Re-submittal Form

Case Name/ Number: PRC2026-00010 / Prairie Pass

Comment ID	Review	Date Received	Source / Agency	Permit / Document	Feedback / Comment	Feedback Response	Status
PLN02-RD2	2	7/10/2026	Planner Review / Greg Barnes	PRC2026-00010	Staff recommends that perimeter fencing be constructed of wood, masonry, or other durable architectural materials rather than galvanized chain-link to better preserve the rural character of the area.	Chain-link perimeter fencing is proposed to secure the project site. Prairie Pass will be critical infrastructure for the regional electric grid and chain-link fence topped with barbed wire is necessary to keep the site secure. Furthermore, chain-link fence construction is typical for ESS projects like Prairie Pass and would be consistent with the nearby Green Valley substation where the project will connect to the electric grid. Any potential fabric used as screening on the fence will be consistently inspected and maintained to prevent tears.	Closed

PRAIRIE PASS PRELIMINARY CIVIL PLAN SET

1 GRADING AND DRAINAGE PLAN
C-300 SCALE 1"=50'

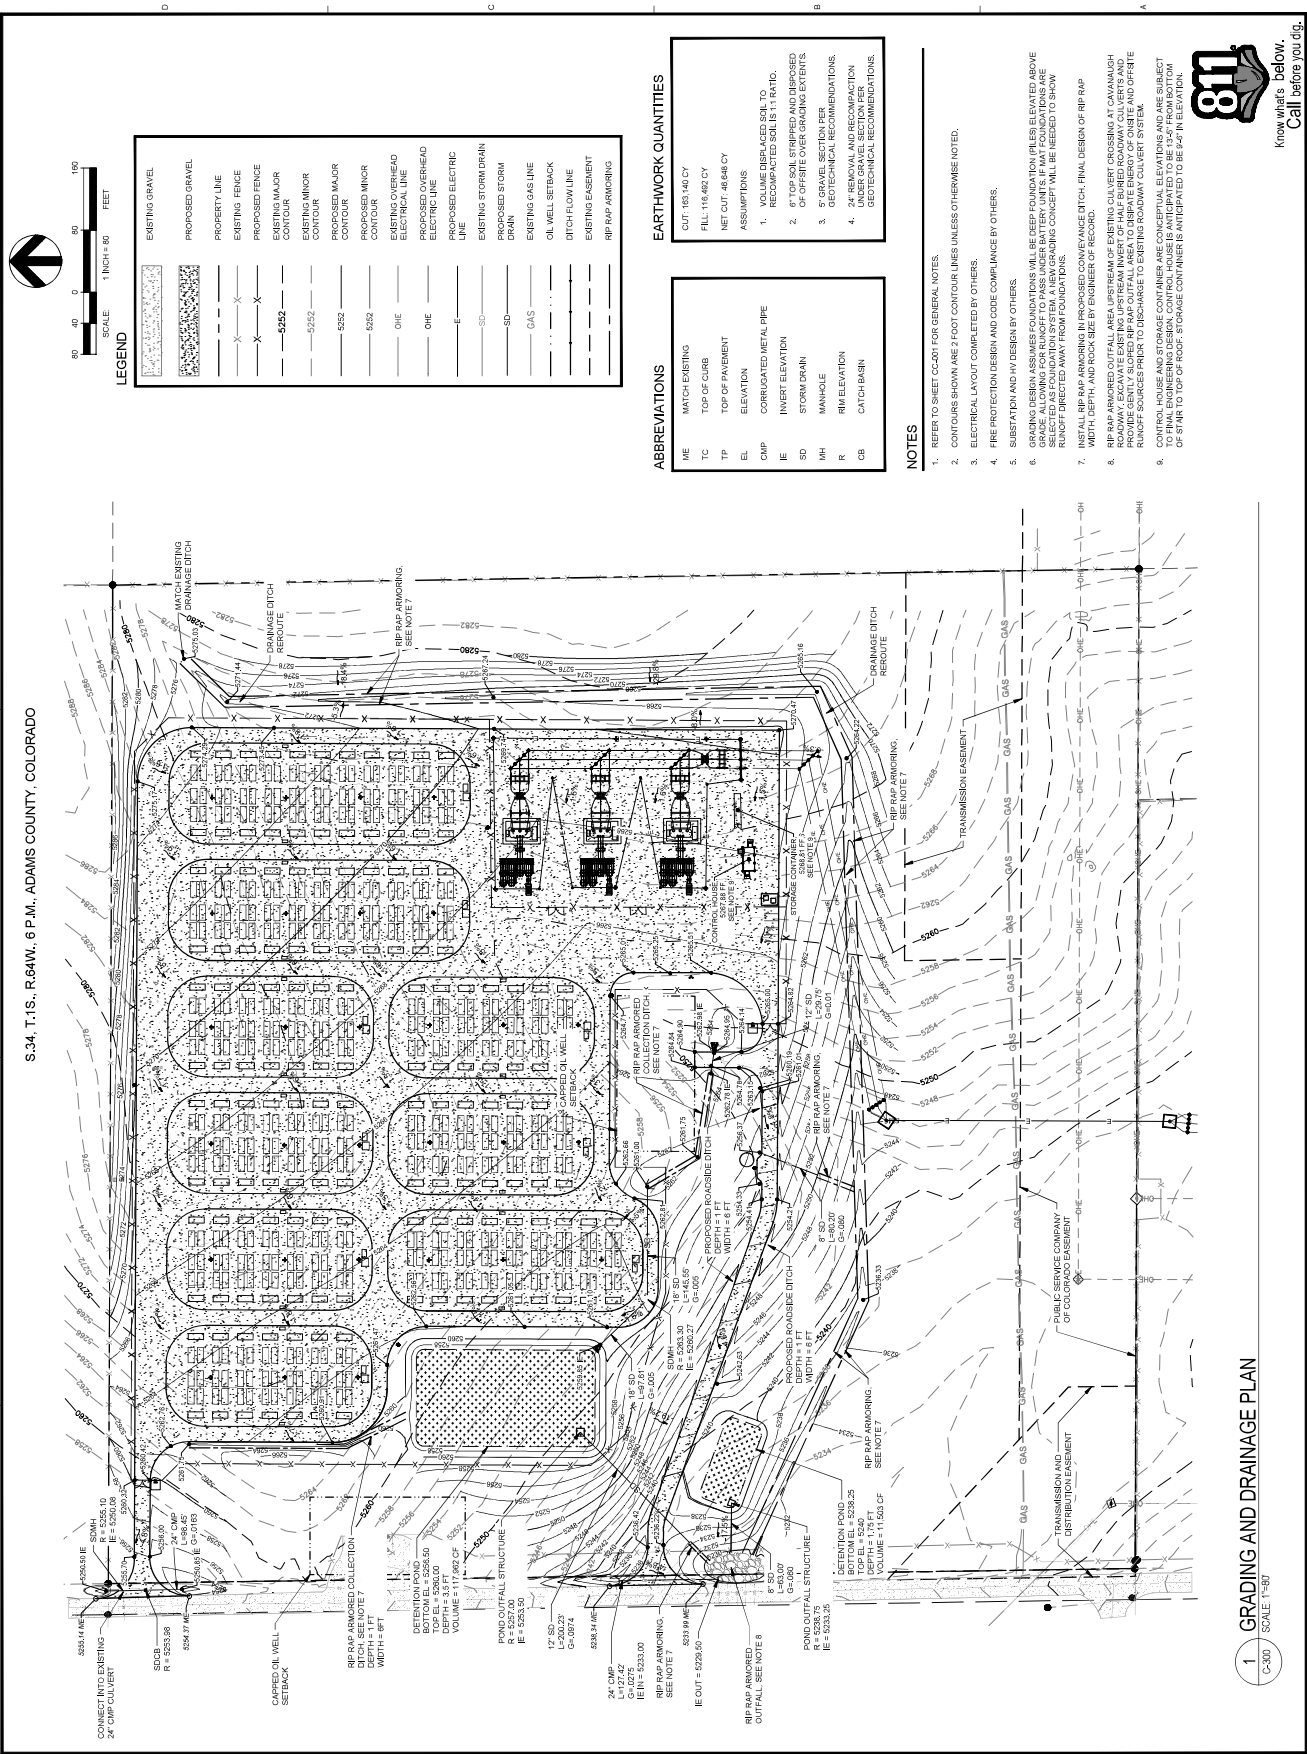
PLN08-RD2	2	7/10/2026	Planner Review / Greg Barnes	PRC2026-00010	Please clarify whether the proposed 8' x 40' O&M Connex is intended to be an occupiable structure. If so, please describe its intended use and identify any additional occupied structures proposed as part of the project, including the control shelter and conditioned trailers referenced in the Project Description. Please ensure the site plan and project narrative are consistent regarding the number, location, and use of all occupied structures. Building elevations should be included.	The O&M connex is akin to a shipping container. The space and any other spaces on the project site will not be used for human habitation, they will not contain space for sleeping, they will not have a bathroom, and they will not have a space for cooking. The connex structure will be intermittently used to gain access to tools and spare parts for the project. Therefore, the connex and other structures on site are not occupied structures and are more akin to 'unoccupied structure features' as set forth in the Adams County Development Standards & Regulations. The project does not contain occupied structures.	Closed

9. CONTROL HOUSE AND STORAGE CONTAINER ARE CONCEPTUAL ELEVATIONS AND ARE SUBJECT TO FURTHER DESIGN. CONTROL HOUSE IS ANTICIPATED TO BE 10' TALL. STORAGE CONTAINER IS ANTICIPATED TO BE 8' TALL.
